MEMORANDUM

RE: LS Residence (Permit #1708-086), Mercer Island Corrections Notice 1, dated 1/17/18.

Structural Calculations for Correction Notice Item S2.0 – Note 1

Title LS Residence_insulated wall
Job # :
Description....

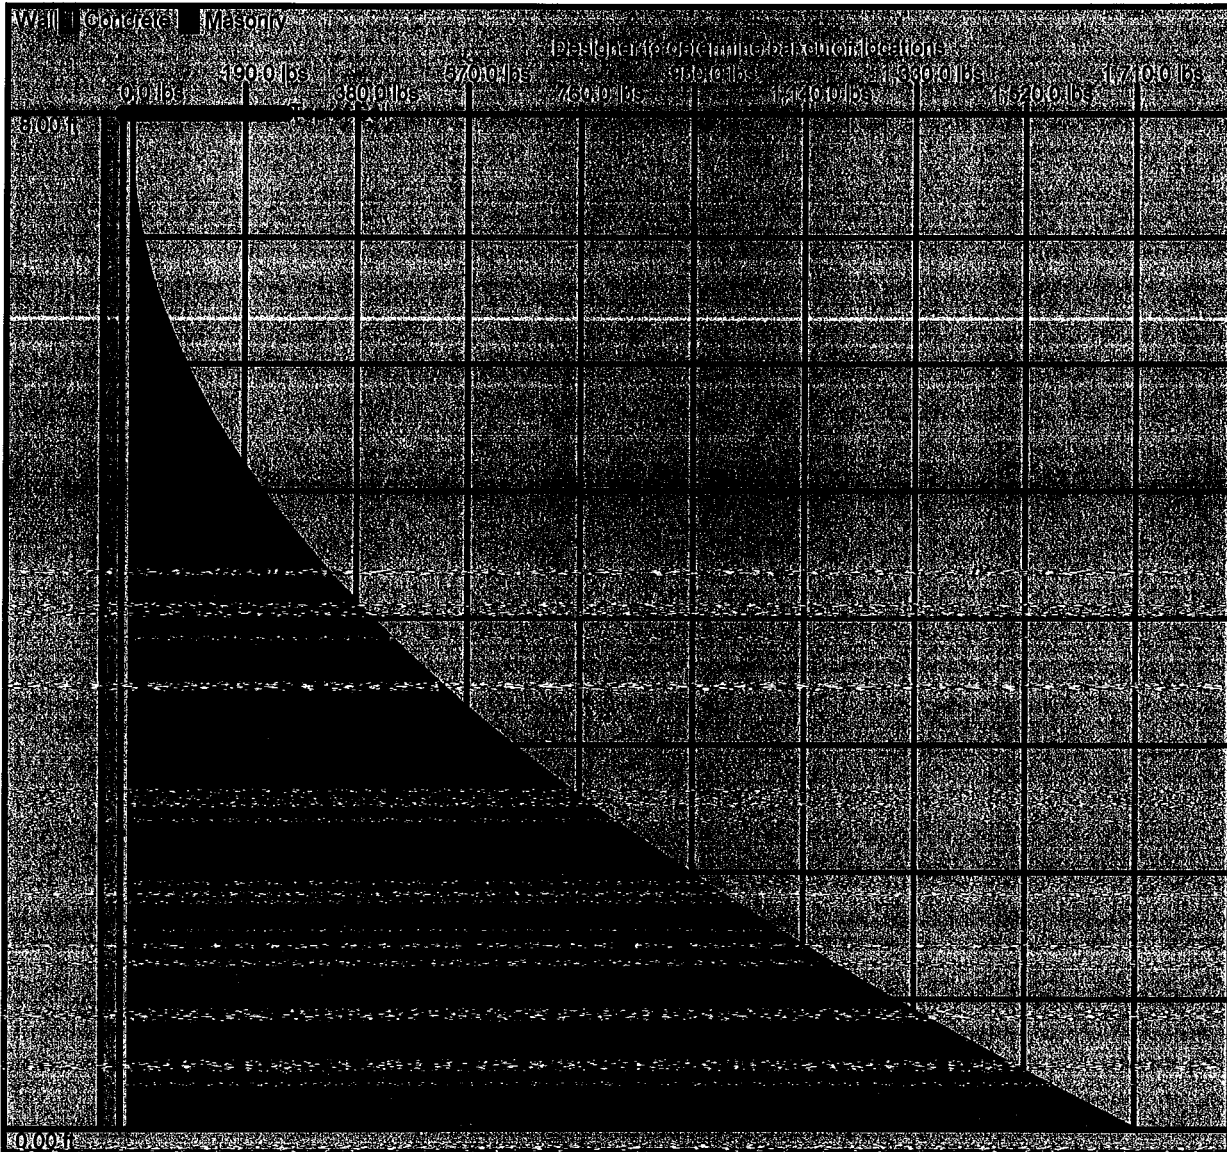
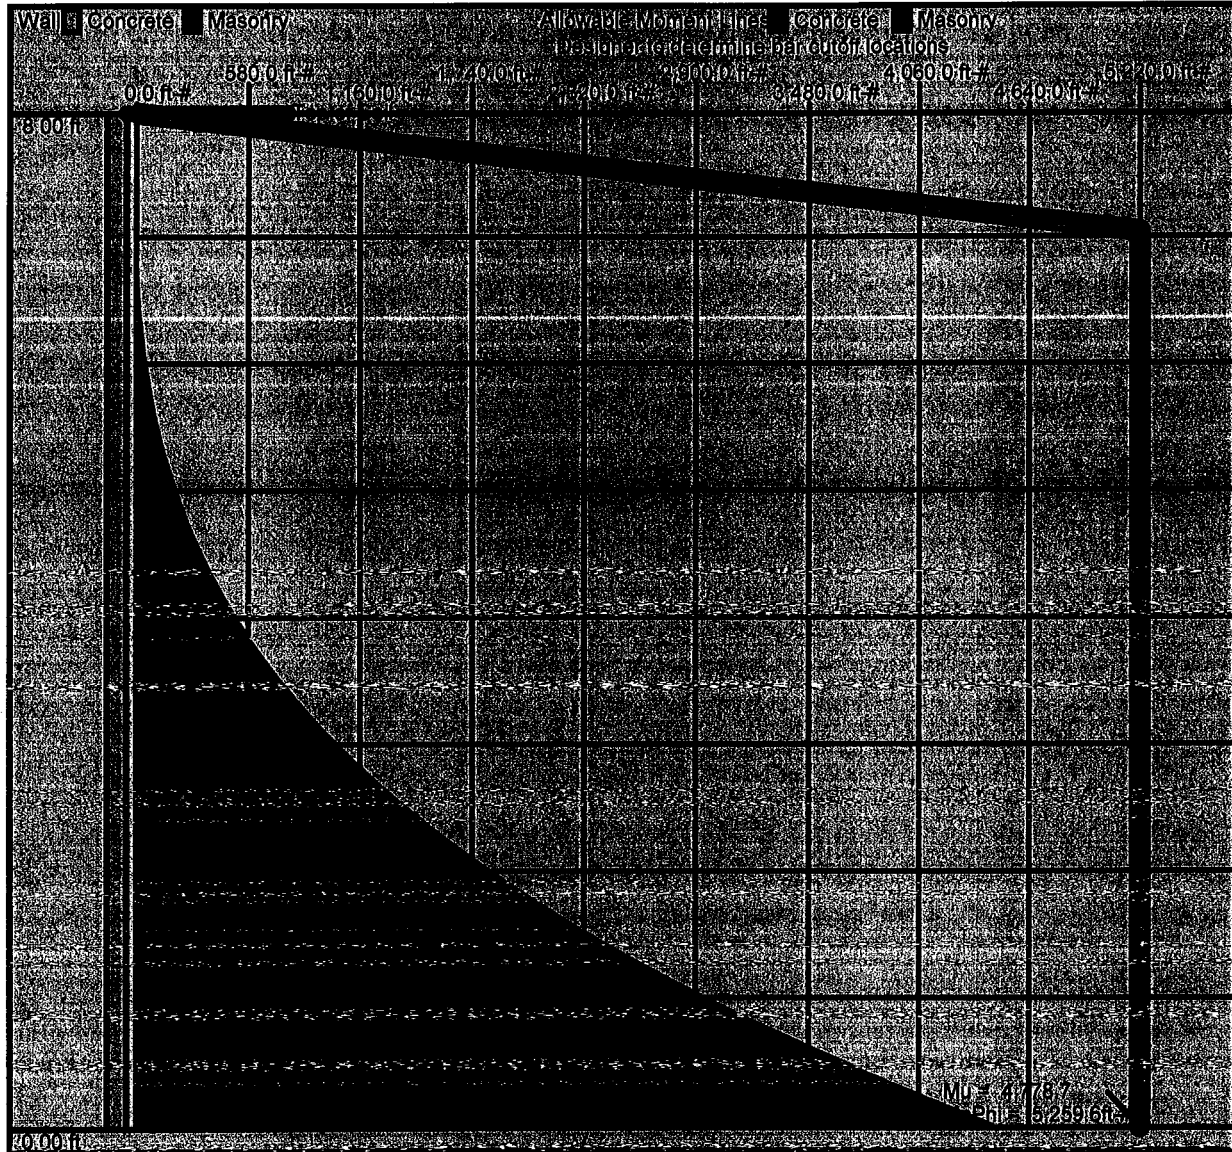
- 2) *Provide calculations for retaining wall shown in 12/S3.1*

See Attachment B for retaining wall calculation.

1 MAIN FLOOR FRAMING PLAN (BASEMENT WALLS)
SCALE: 1/4" = 1'-0"

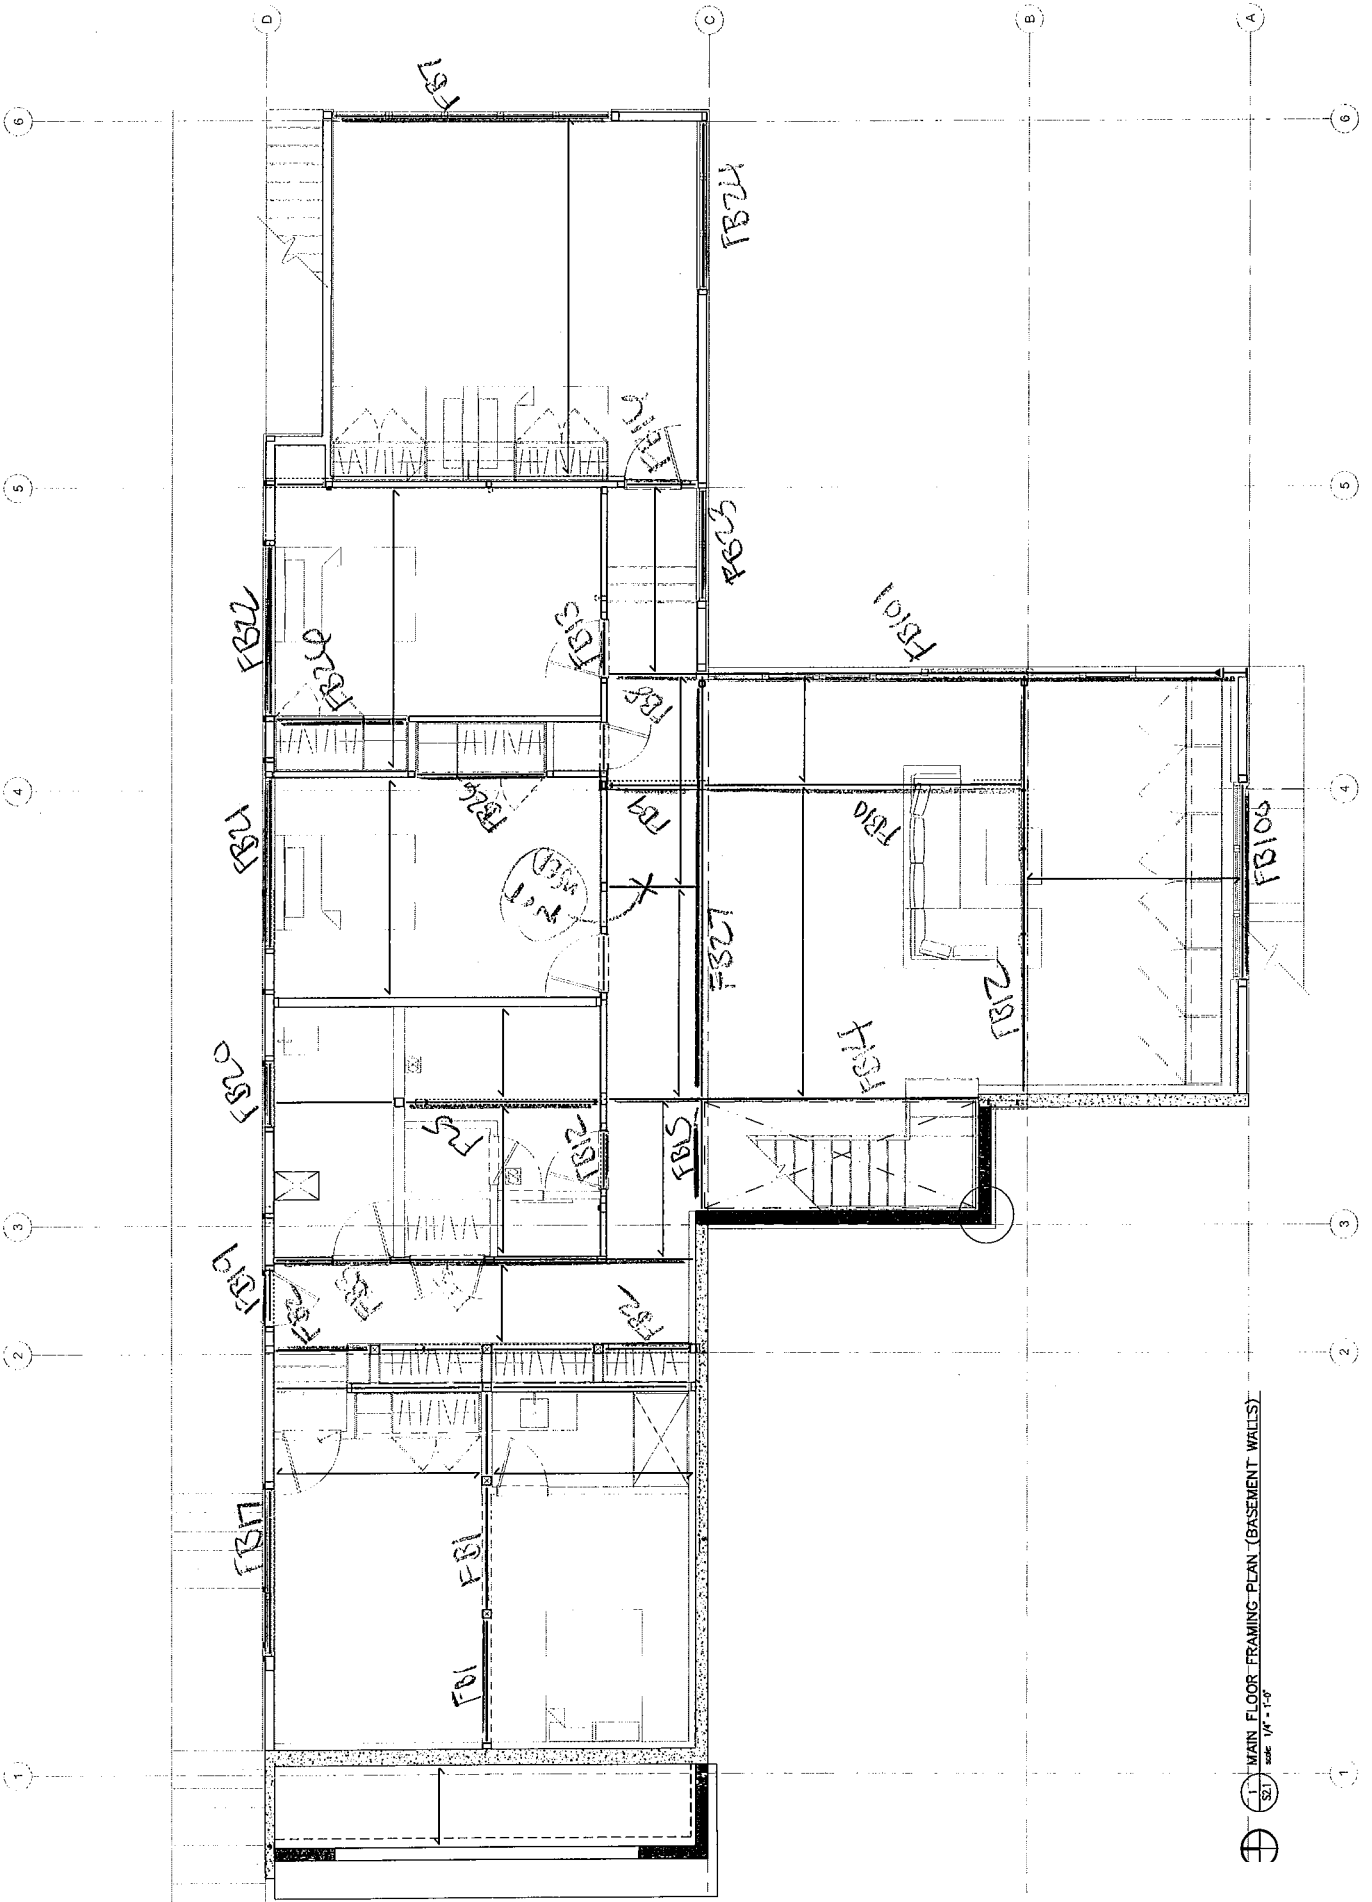
- 2) *Calculations and beam layouts and callouts don't appear to be coordinated with the main floor framing*

- 3) *Please review gravity calculations and callouts. This beam is noted as FB27 and no calculation is found in the packet.*

- 4) *Please review gravity calculations and callouts. This beam is noted as FB12 and no calculation is found in the packet.*

- 5) *This beam is noted as moment frame but not included in lateral calculation (or gravity design). Provide a complete narrative and design for the structure here.*

- 8) *Please review gravity calculations and callouts for main floor framing vs calculations provided and keyplan on calc page 12/78. There appear to have been revisions to framing following the calculations.*

New beam layout and corresponding beam calculations have been updated to match.

FB27 has been added/updated in calculations and beam map in Attachment C.

FB12 has been added/updated in calculations and beam map in Attachment C.

FB101 has been added in calculations and beam map in Attachment C. This beam has been designed for lateral and gravity loads.

Gravity calculations and main floor framing callouts have been updated on plans and in Attachment C calculations. Upper floor loading has been revised in locations where previous calculations differed from the proposed plan.

1 SECOND FLOOR FRAMING PLAN (MAIN FLOOR WALLS)
 S2.2
 SCALE: 1/4" = 1'-0"

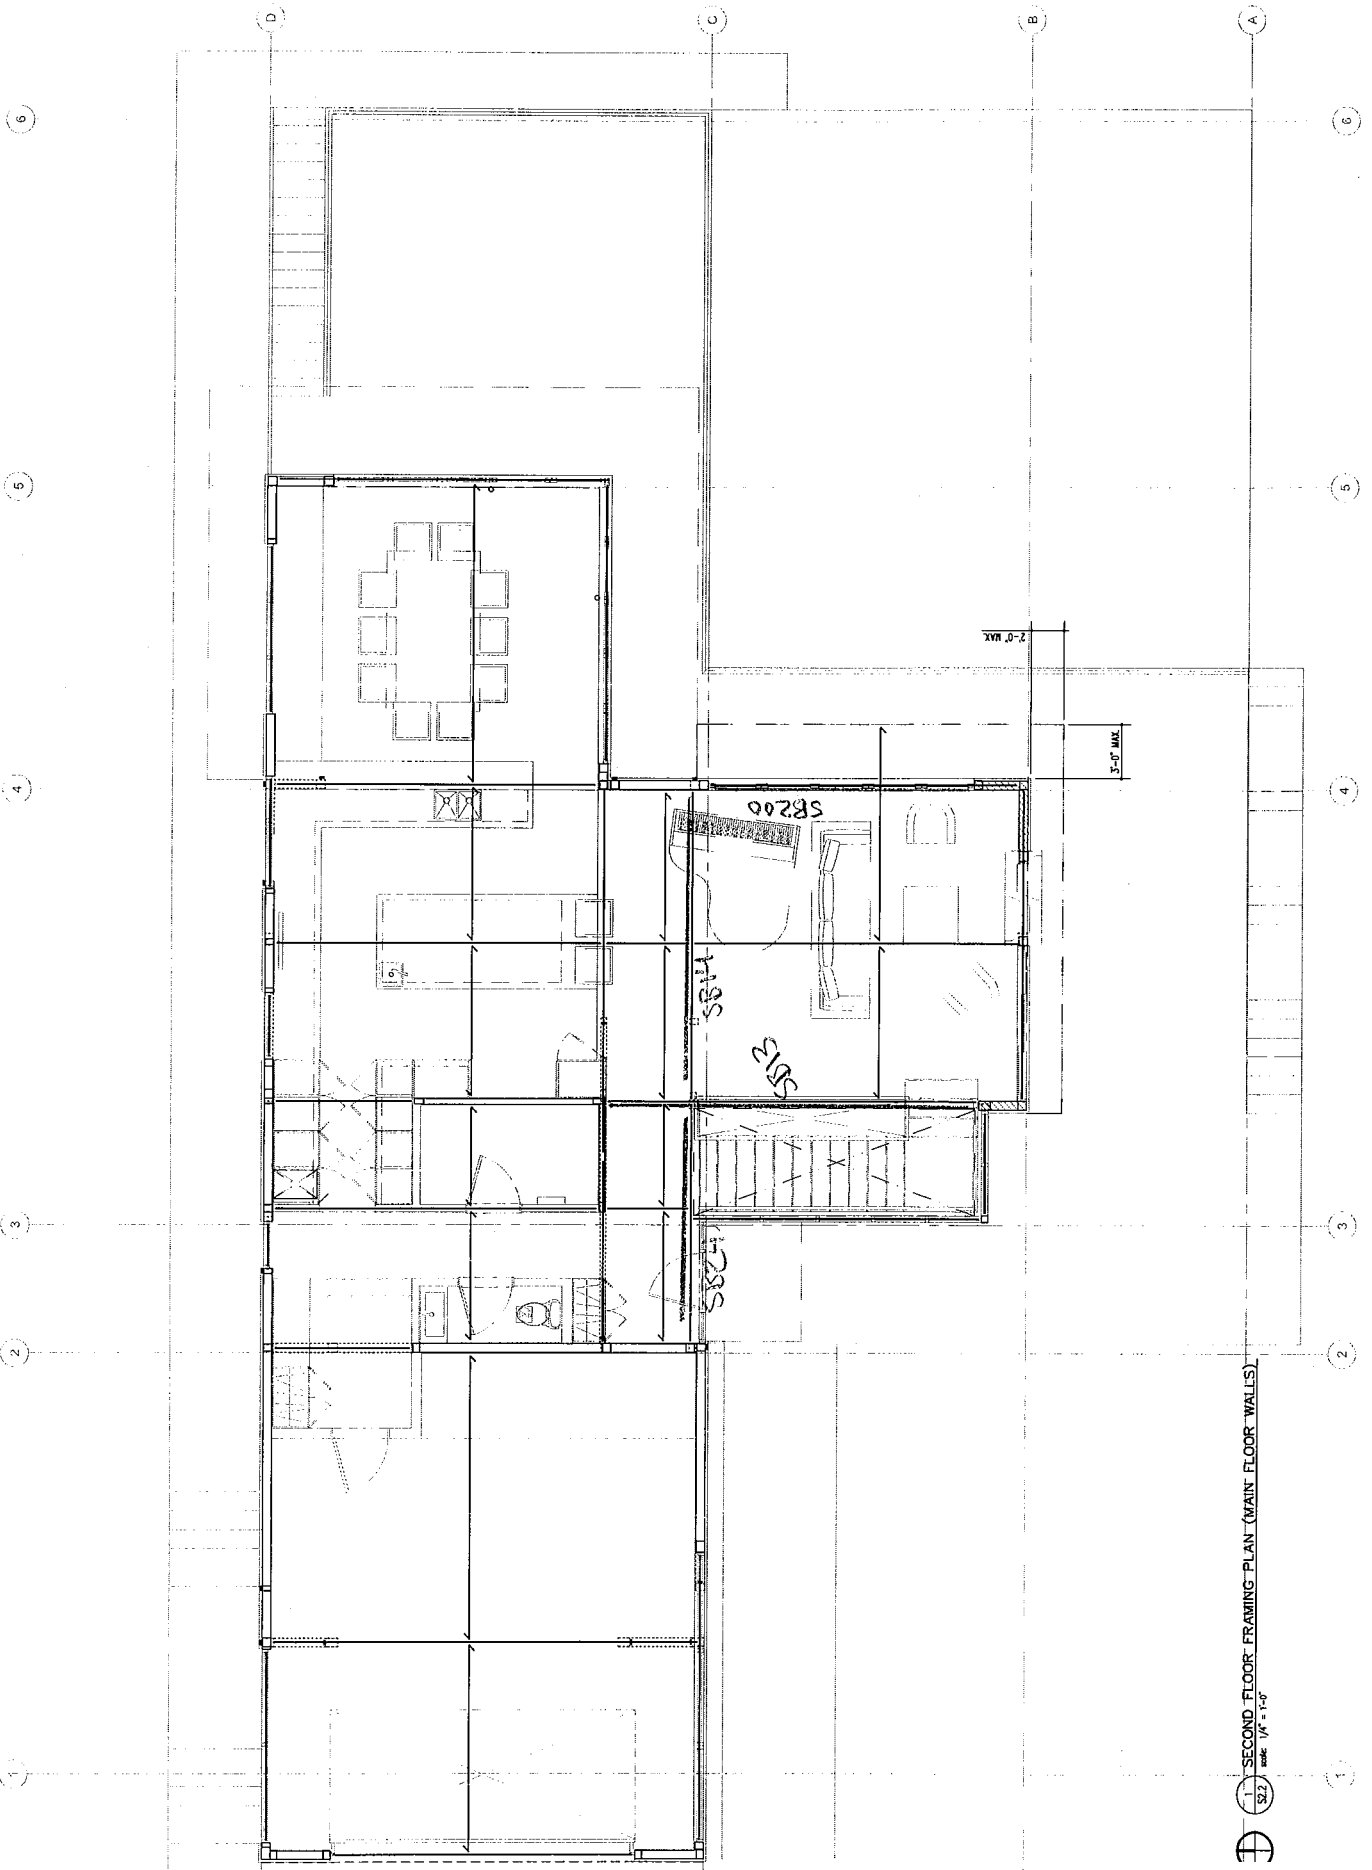
- 3) *Second floor key on calculation page 11/78 also calls this beam SB13 (I think). See other comment this sheet. No calc for this MC13 or the W12x30 supporting it (nor any W12x30) were found in the calculations. The gravity calcs may be a partial set?*

- 5) *Is there a post here not called out on this level?*

- 6) *Provide collector and drag connection design for SW4 along grid 5.*

- 7) *Provide collector and drag connection design for SW6 along grid 4.*

- 8) *Provide a detail of this post offset. These posts do not appear on the level below.*

- 9) *Clarify floor beam calculations. This beam appears to be called out on key as SB13. Calculations Jump from SB10 on page 34/78 to SB20 on page 35/78. Verify in the calculation for this beam that deflection is coordinated with detailing of or manufacturer's tolerance for vertical deflection at the sliding door below.*

Calculations for beam SB13 and the corresponding supporting beams (SB14 & SB24) have been included.

(2)2x6 post has been designed and added to the plan set in this location.

W12x30 beam serves as the drag strut/ collector for this shearwall.

Northern W12x30 has been extended to span over the grid 4 SW to collect floor loading in the SW. Strap has been added to the face of this beam and adjacent GL beam to drag southern diaphragm loads into SW.

New post has been added to the plans to support this point load. Loading from new post has been carried to beam below and is reflected in updated beam calculations found in the updated calculation set.

Beam map has been updated to include calculations for this beam, SB200. Manufacturer recommends a max deflection of 0.25" (or $l/720$). Beam has been updated to a W12x30.

1 ROOF FRAMING PLAN (SECOND FLOOR WALLS)
 SLS
 SCALE 1/4" = 1'-0"

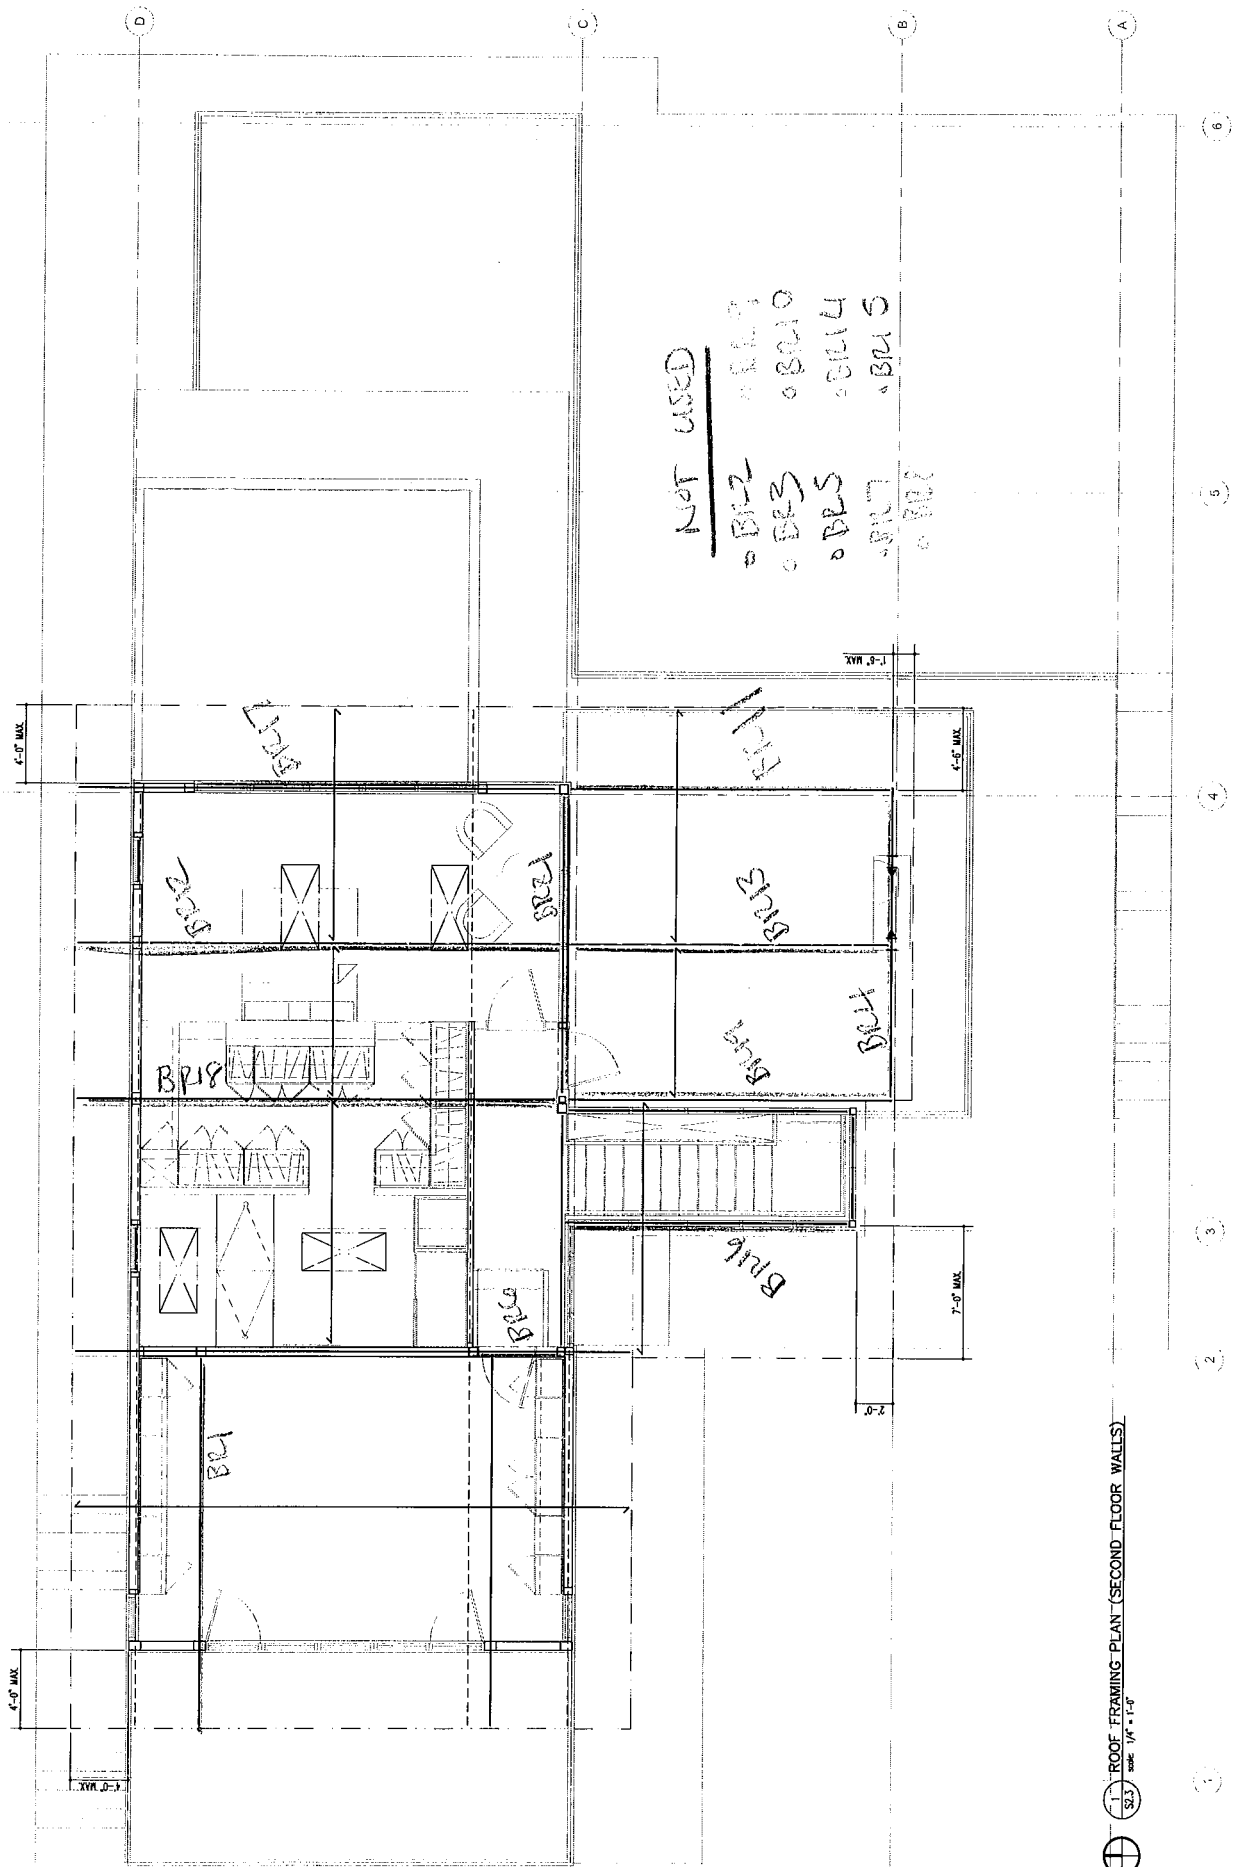
-
- S2.3** 2) *Calculation for BR18 appears to be missing from calc packet. Please check gravity calc packet for completeness against framing keyplan.*

Roof framing beam map has been updated and beam calculations have been updated. Please note beam callouts may skip numerical order as beams from older plan sets have been removed. This should be apparent in new beam map.
